EUT INTERNAL PHOTOGRAPHS

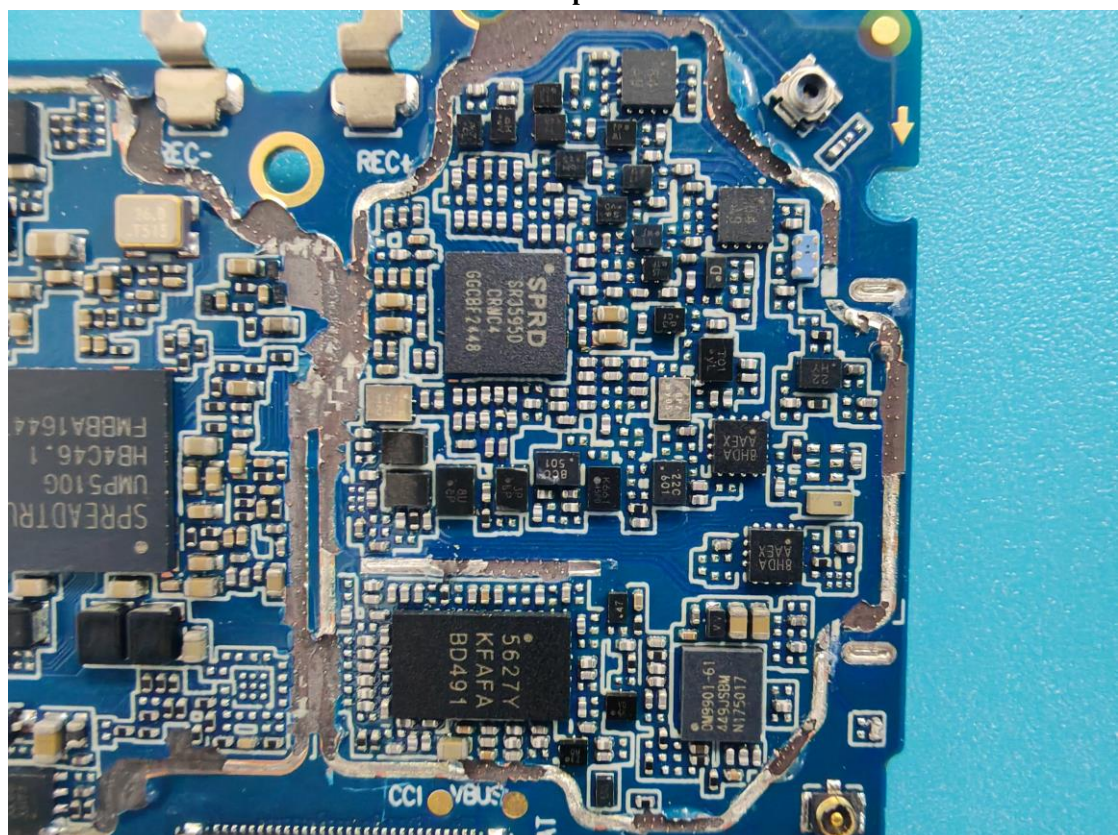
Two TVS and one resistor for fingerprint, two capacitors for CPU's AVDD1V8, and two resistor for CPU1-feedback and delete two caps for UFS power supply

Memory-EMMC

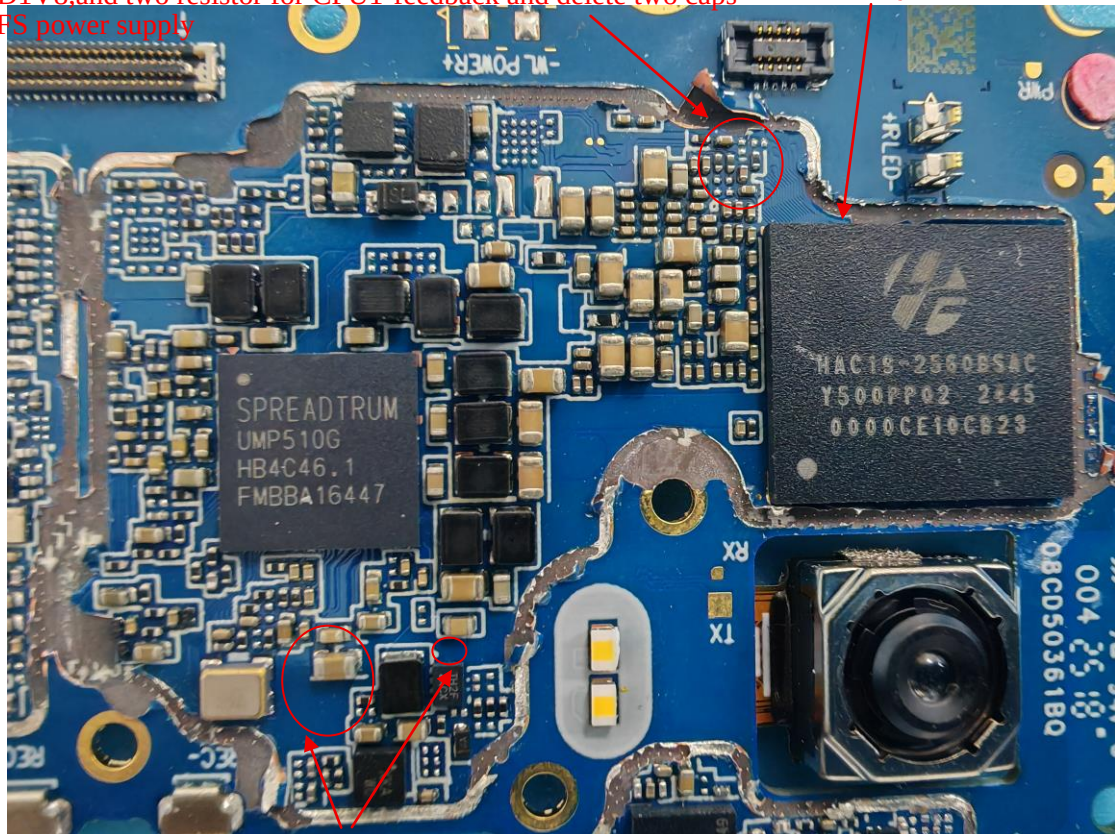
delete compatible LDO for UFS's VDD

WWAN Main Antenna

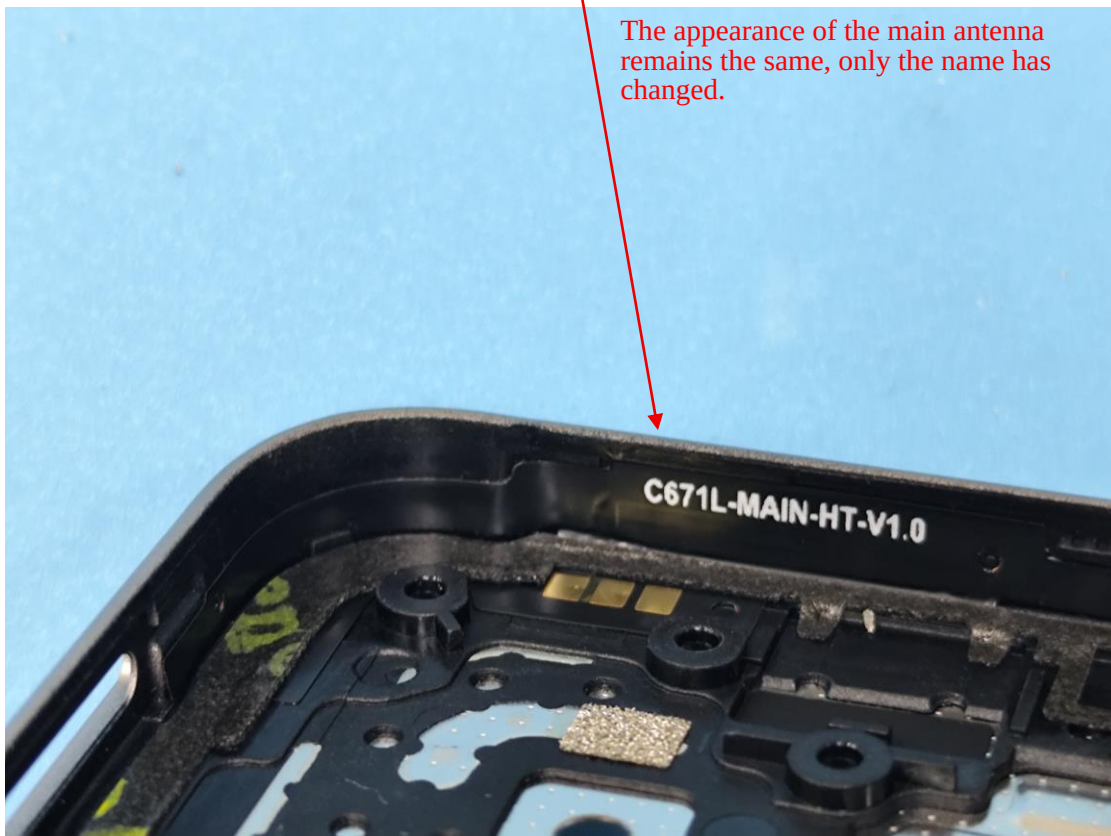
The appearance of the main antenna remains the same, only the name has changed.

Div Antenna

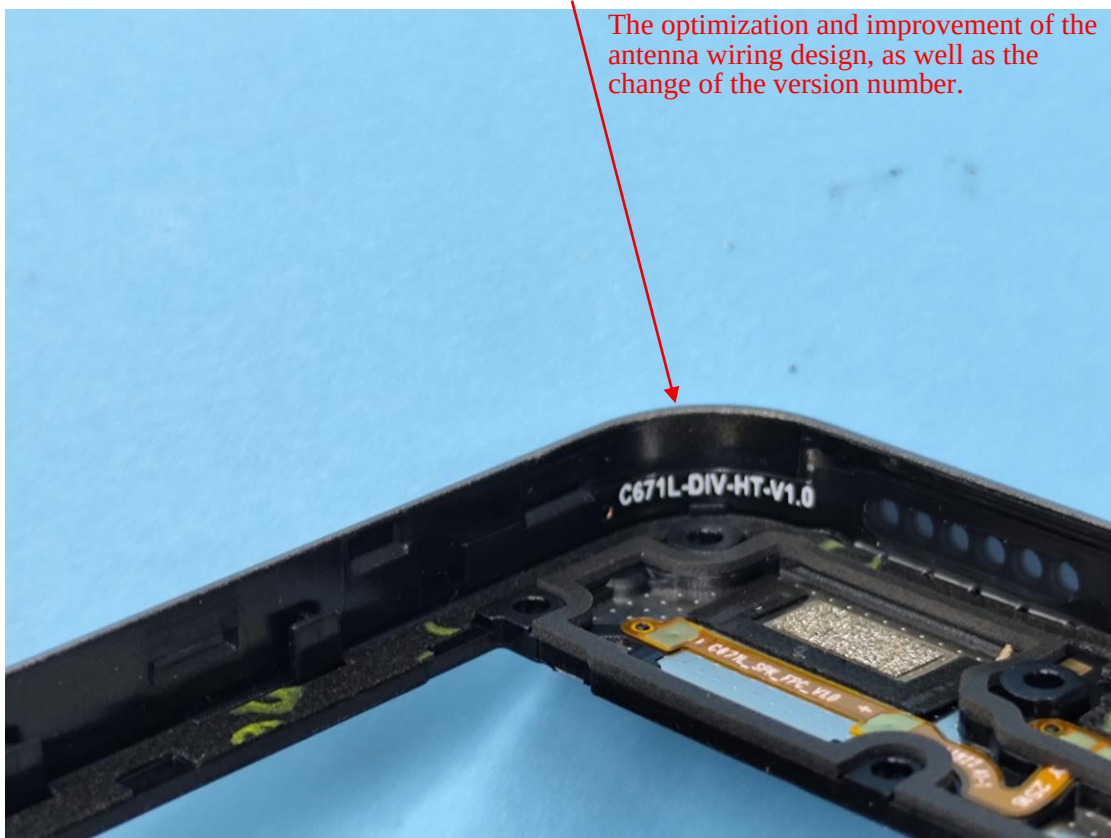
The optimization and improvement of the antenna wiring design, as well as the change of the version number.
